## ADDENDUM NO. TWO

BID TITLE: **Bid No. 6301 – Arvin High School Modernization: Phase 1A Roofing**

**Arvin High School Phase 1A Roofing**

**ADDENDUM NO. 05**

**SHEET NAME:**  
BLDG 1A/1B & 1C - ROOF PLAN - REMODEL

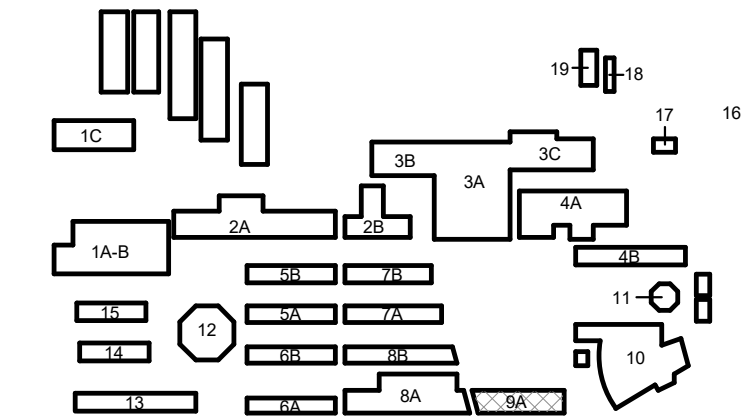
- 1.) REVISE notes as shown and clouded per Delta 5.
- 2.) Bldg 1C is crossed out as shown and clouded per Delta 5.

BLDG 9A - UPPER ROOF PLAN - DEMO & REMODEL

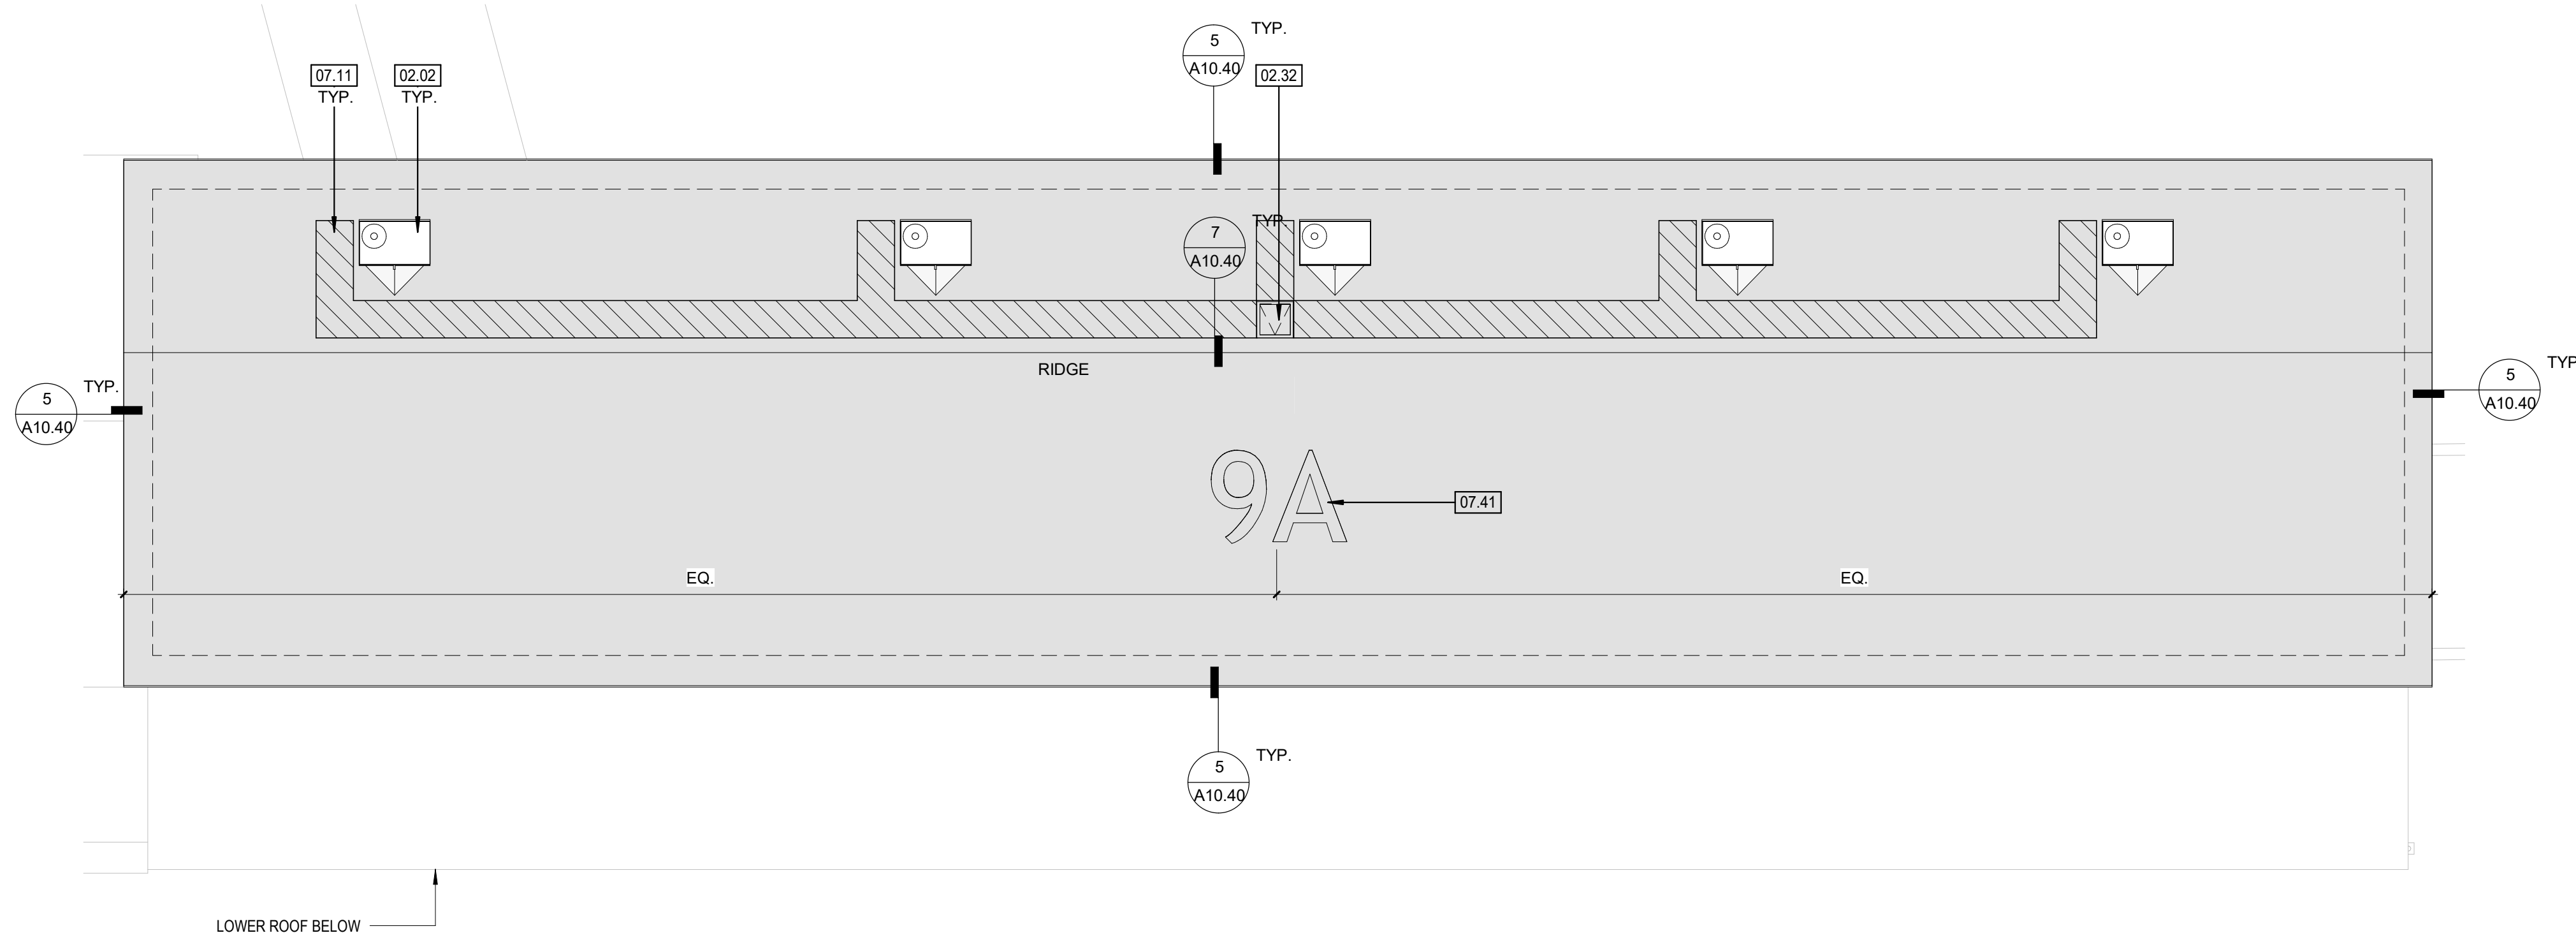
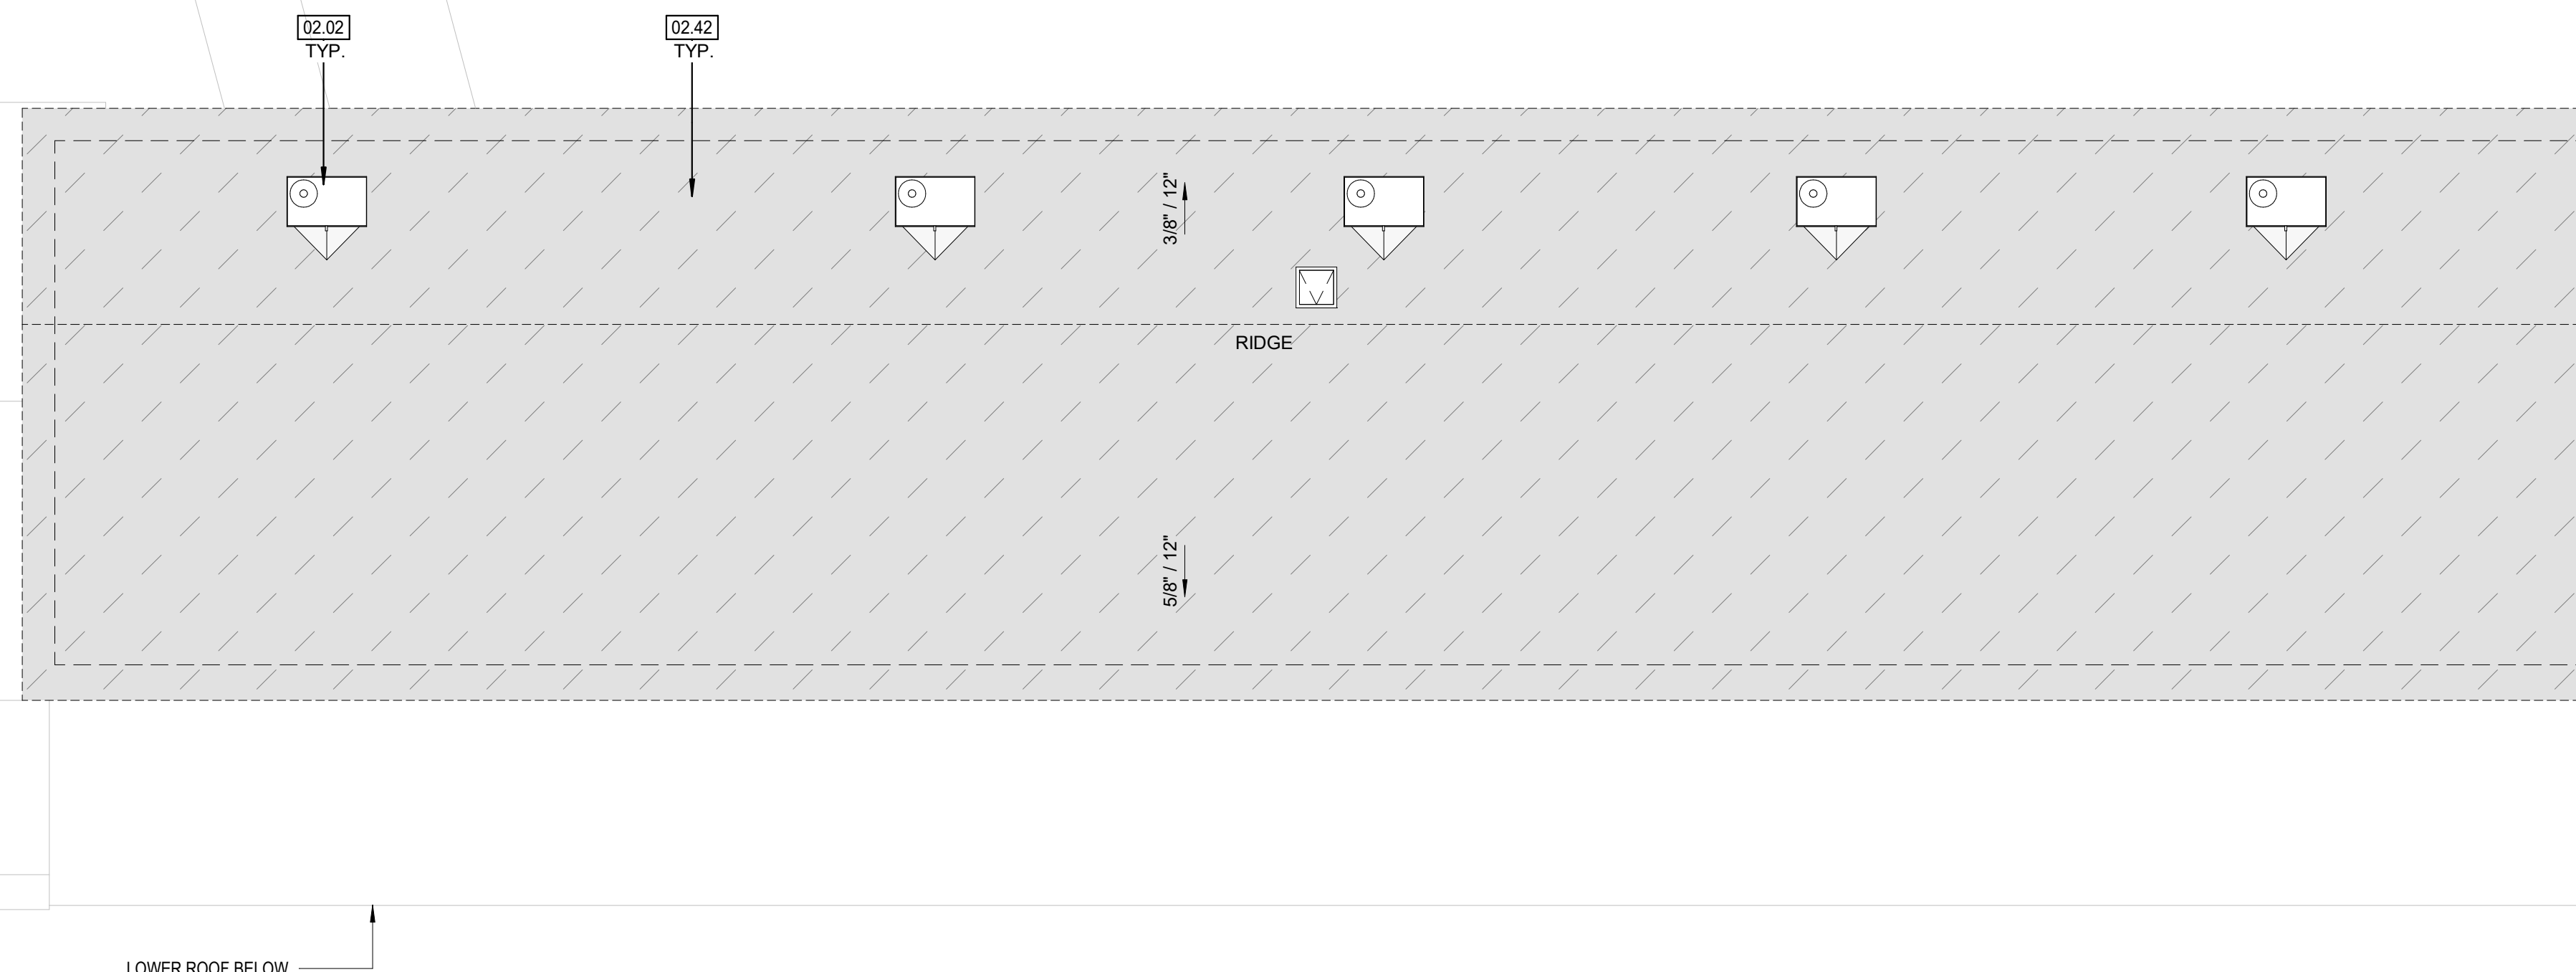
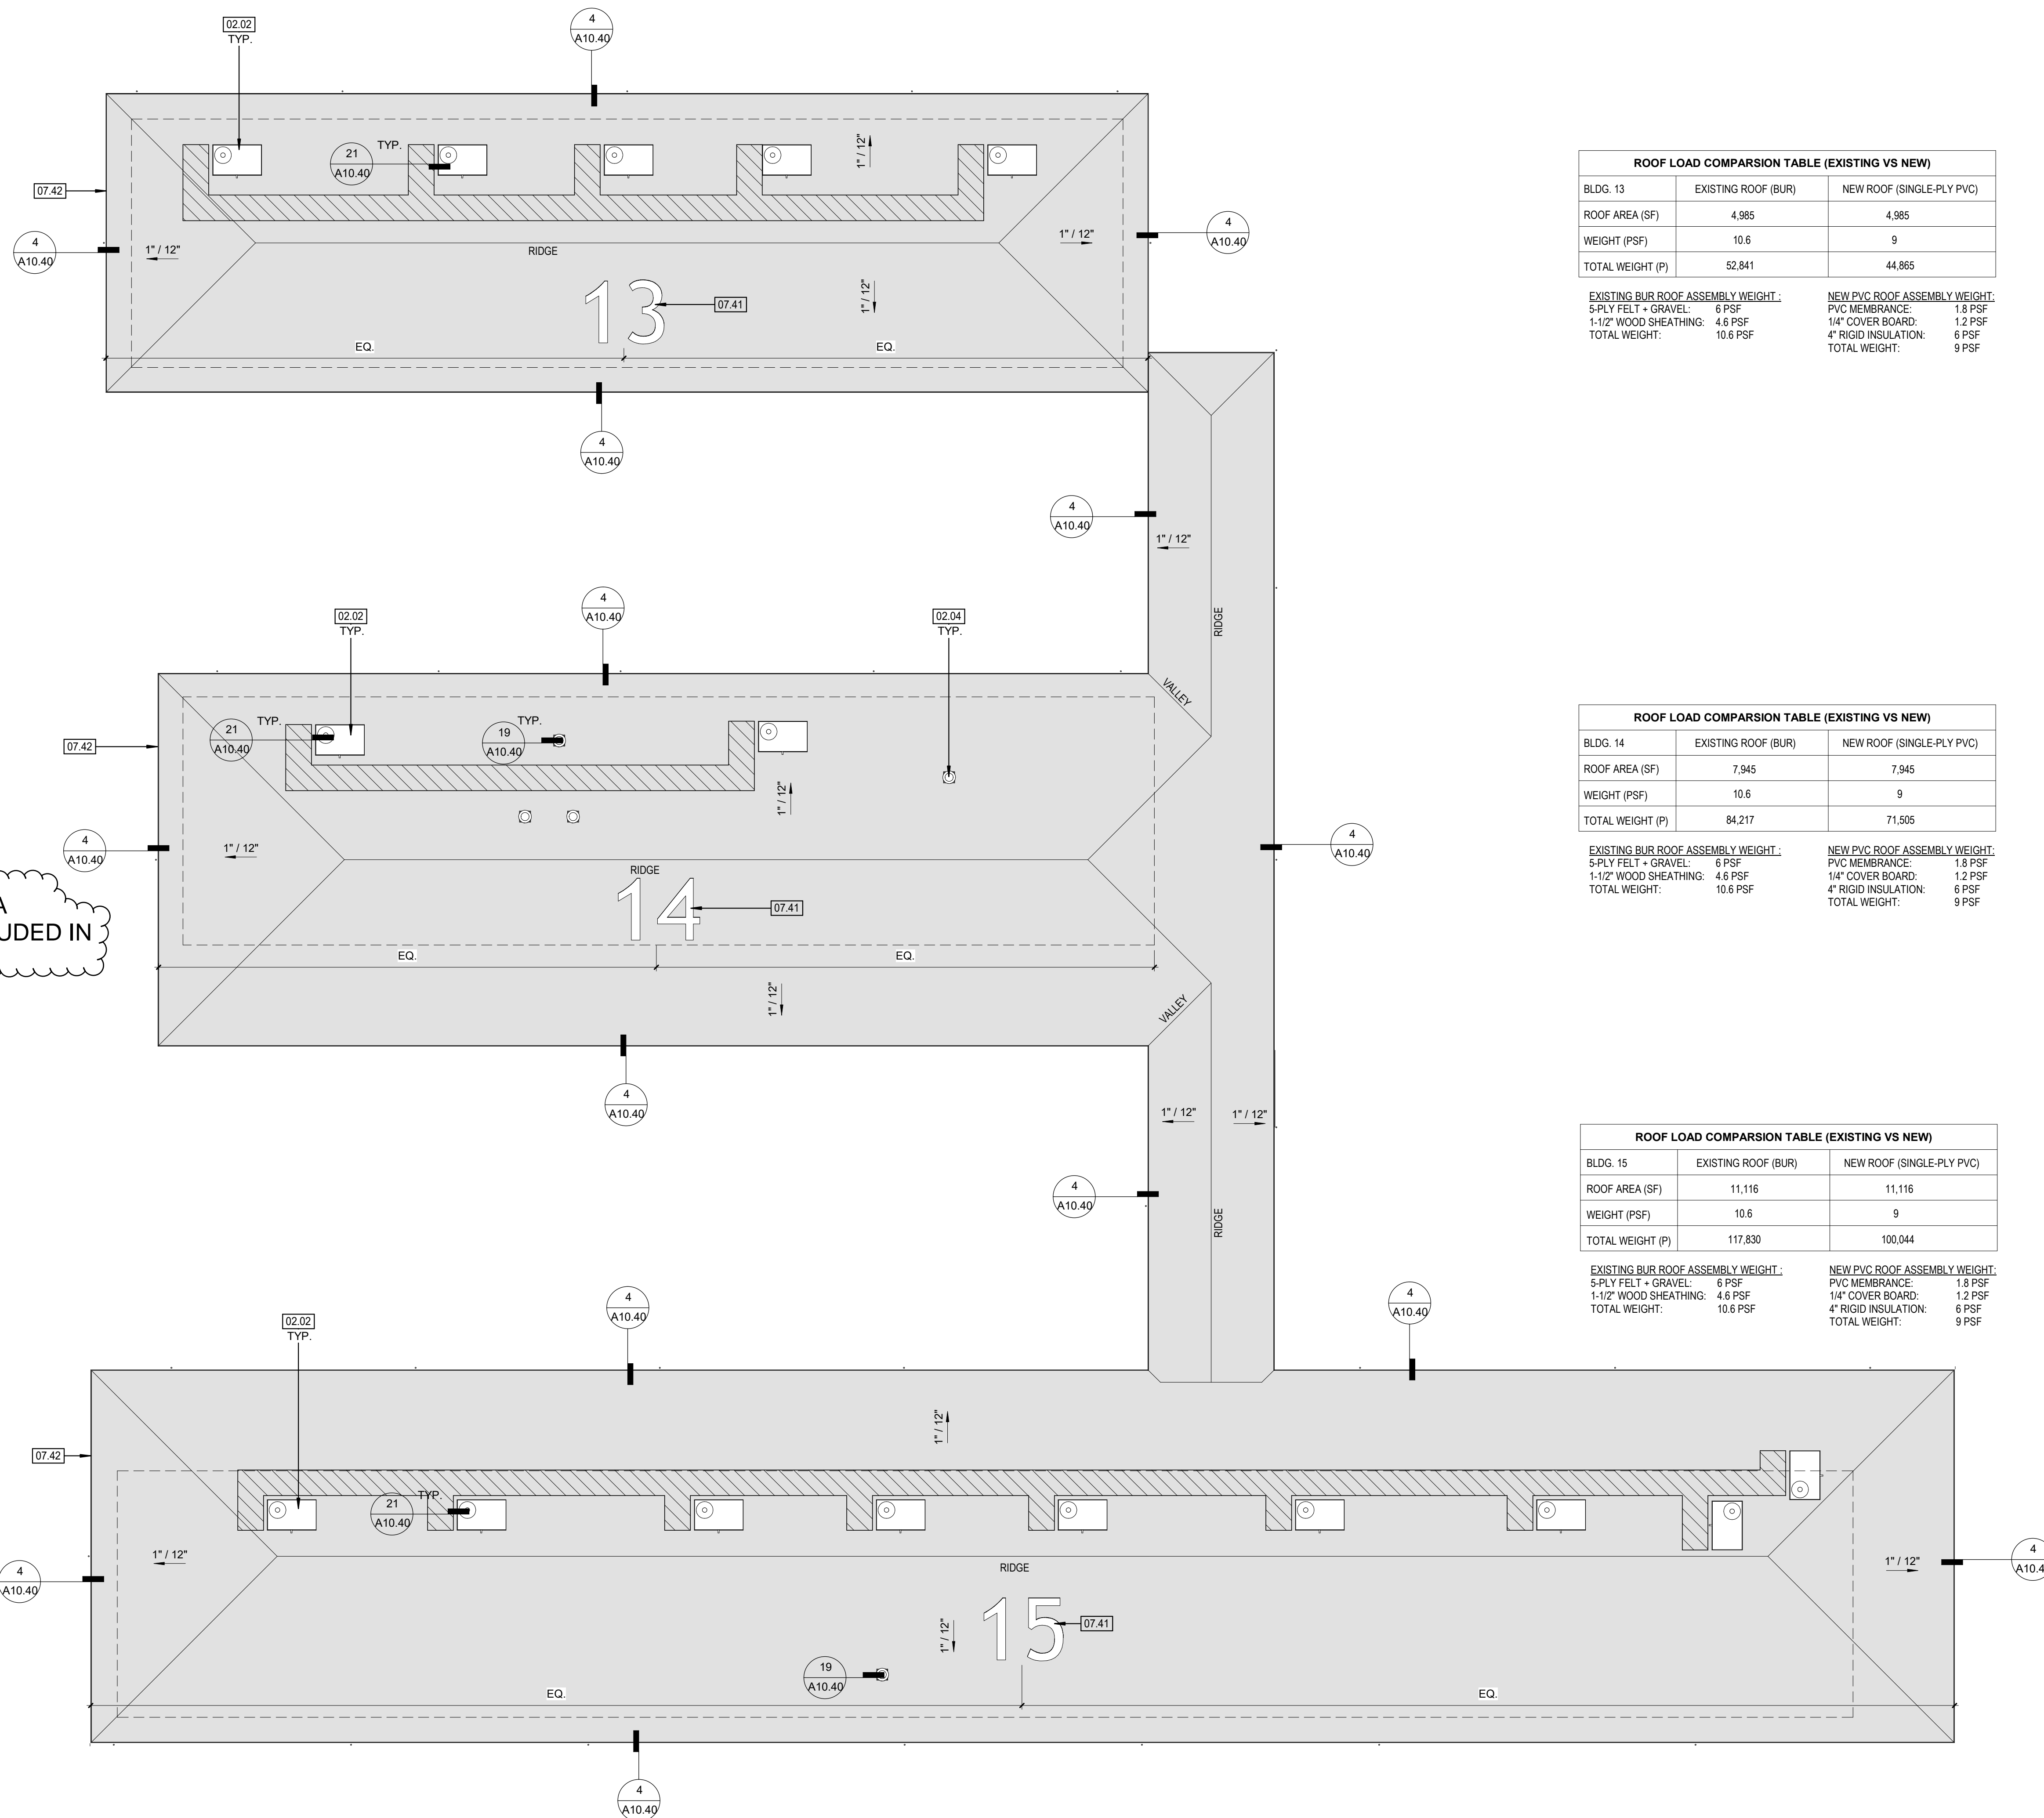
- 1.) ADD & REVISE notes as shown and clouded per Delta 5.
